JEFFERSON COUNTY, TEXAS

ADDENDUM TO RFQ

RFQ Number: RFQ 21-040/JW

RFQ Title: Professional Engineering Services for Drainage Improvements
at the Jack Brooks Regional Airport

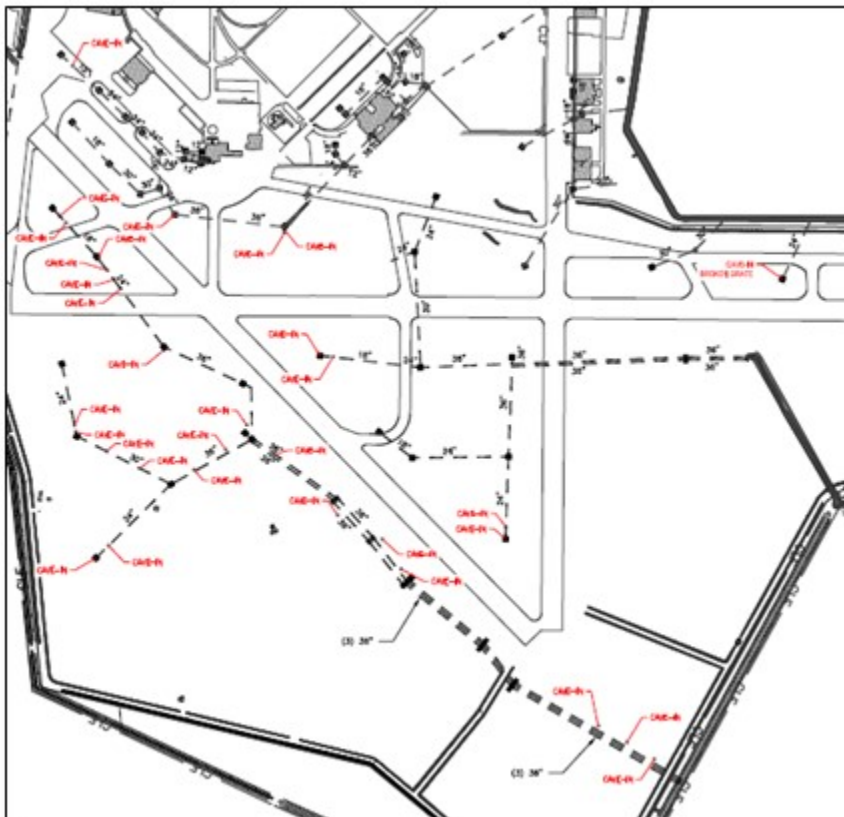
Removing the airfield trees and re-grading the airfield areas will allow water to drain away more efficiently and address areas where ponding water makes mowing difficult. The areas shaded in white below are tree areas that we have removed in the past three years. The reddish-brown and blue shaded areas are the remaining tree areas on the airfield.

The red lines are the approximate locations of the underground RCP.

Once the trees are removed and the RCP is repaired/replaced, we will then regrade the airfield to sheet flow water away from the runways.

We also intend to rehab our drainage ditch that borders the western boundary of the airfield (yellow line in above picture). This ditch flows into Drainage District #7 C-10 ditch and they will be heavily involved in this project.
